Notice of Allowability

10/664,138

EXAMINER'S AMENDMENT

Fig-3A

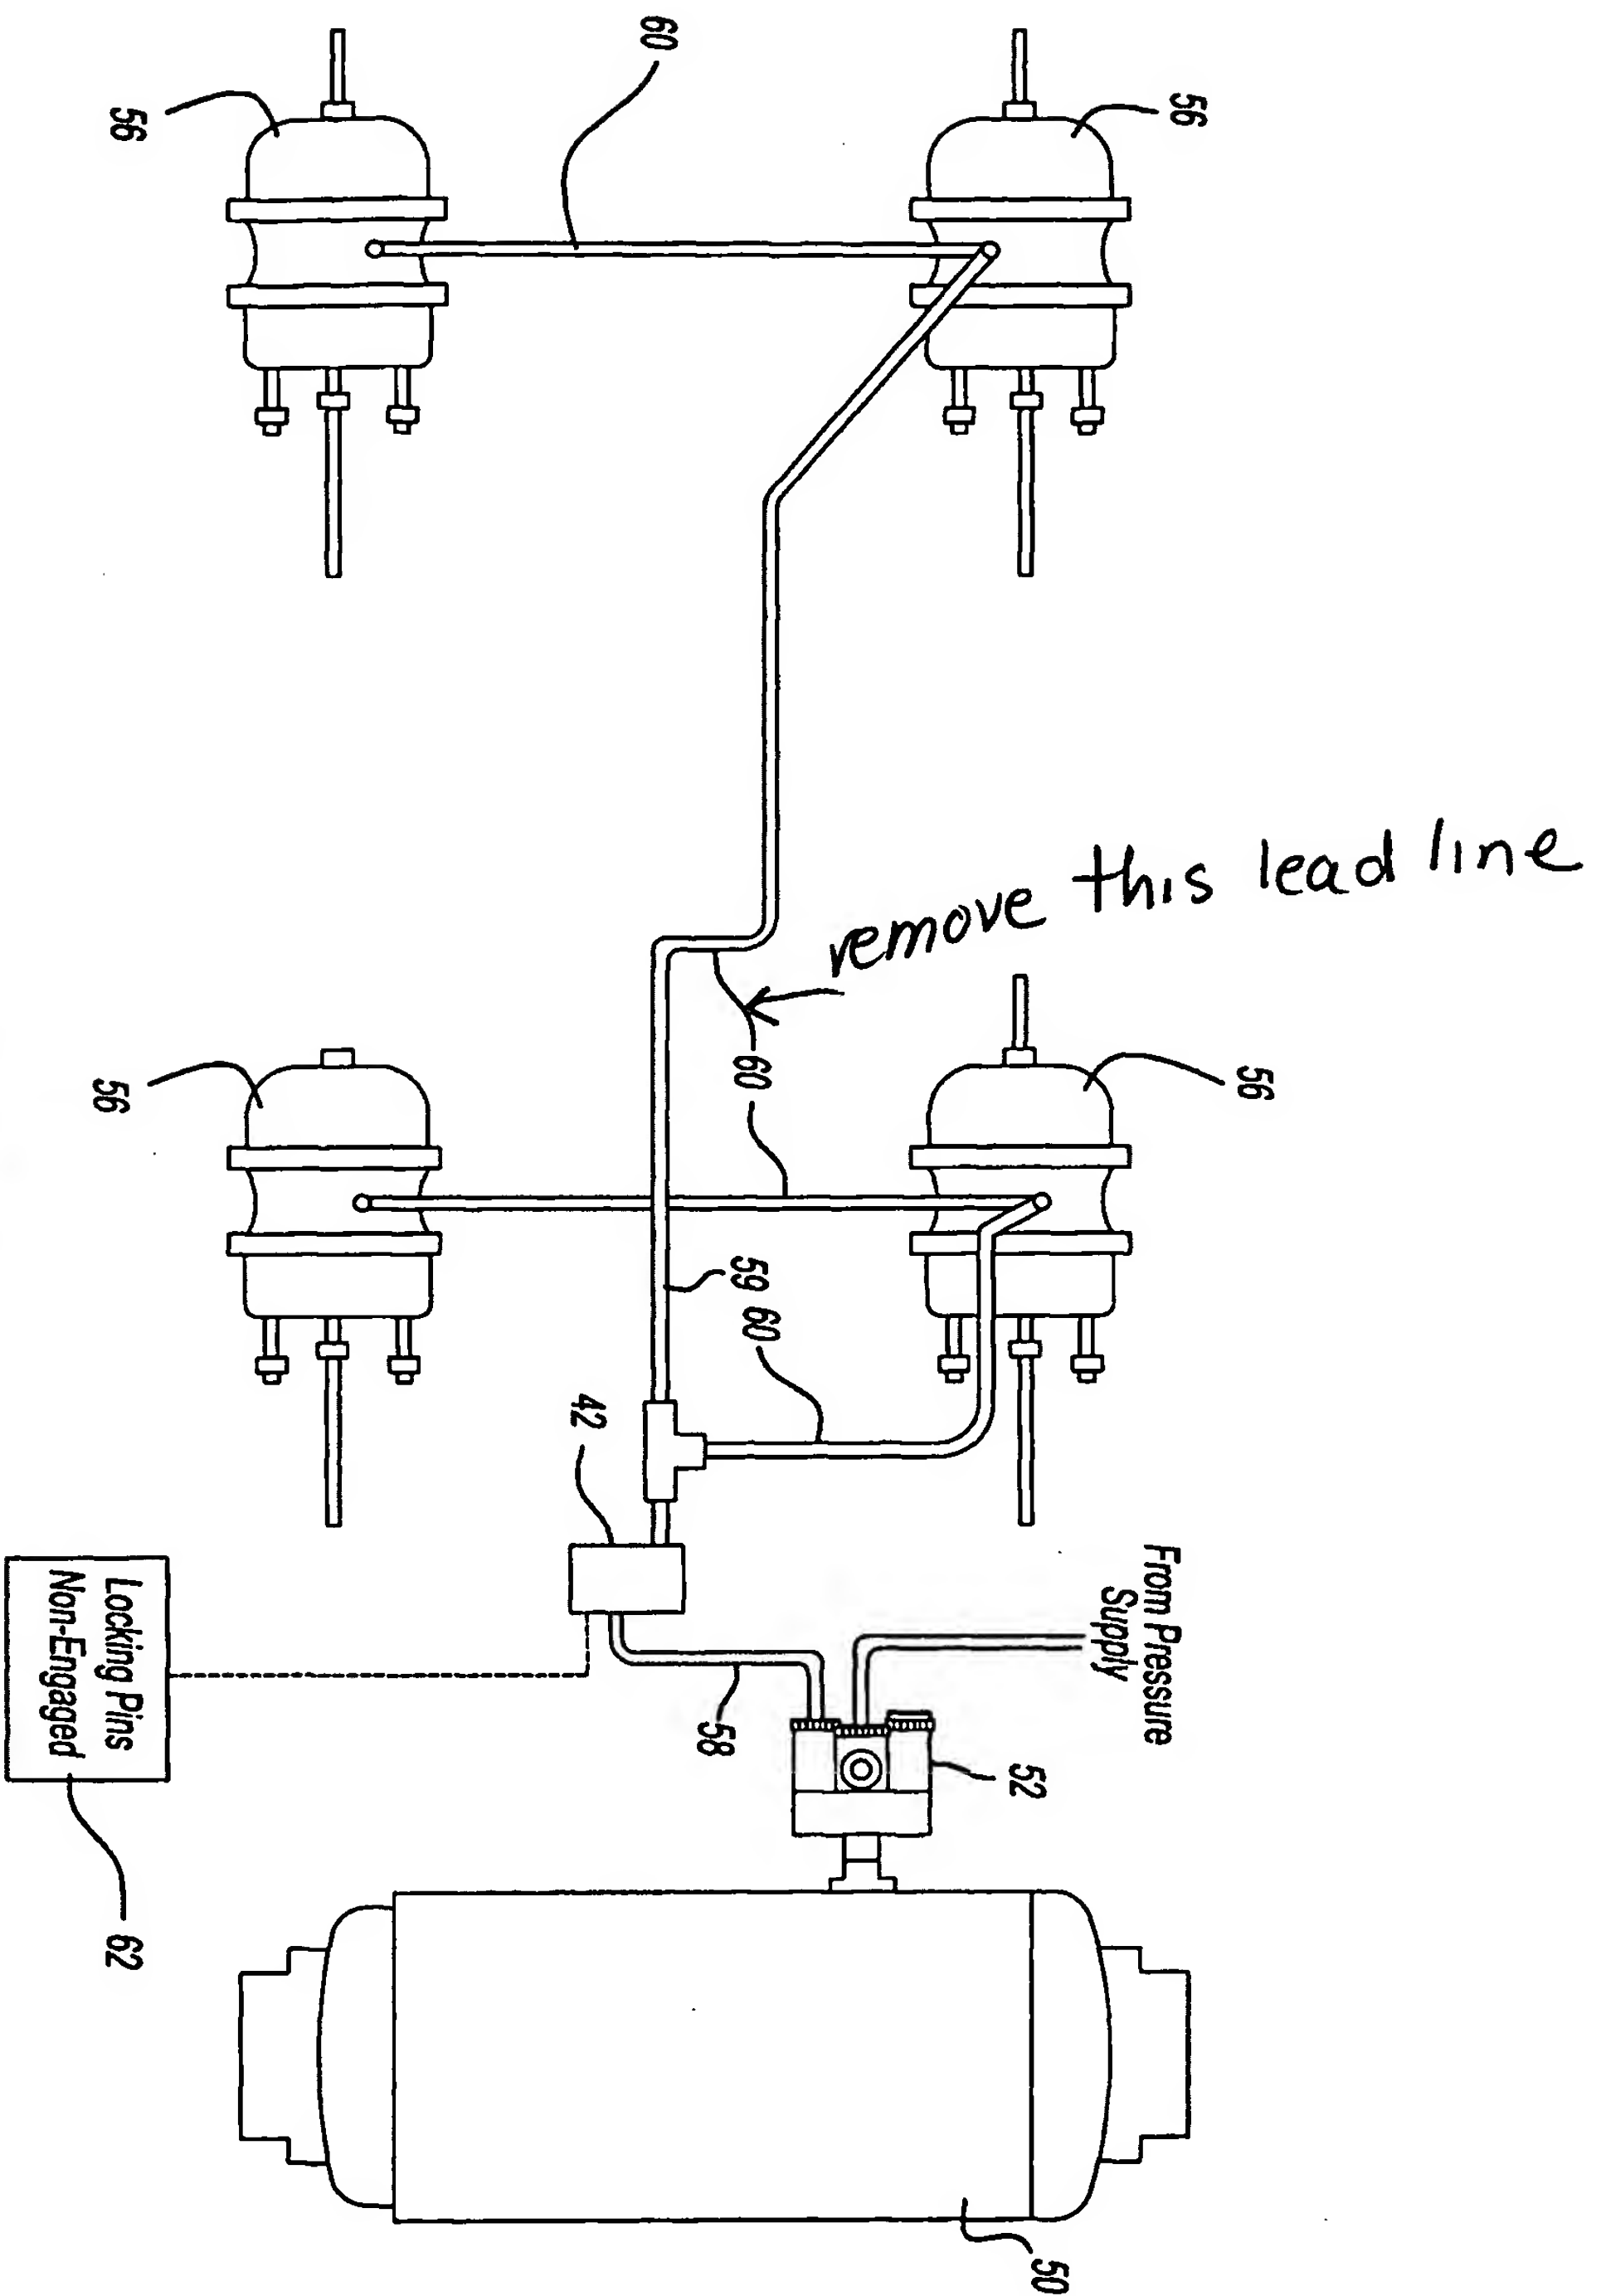
2. The following changes to the drawings have been approved by the examiner and agreed upon by applicant: As shown in the attached Figure, the second lead line associated with the reference 60 in the center of the page has been deleted. In order to avoid abandonment of the application, applicant must make these above agreed upon drawing changes.
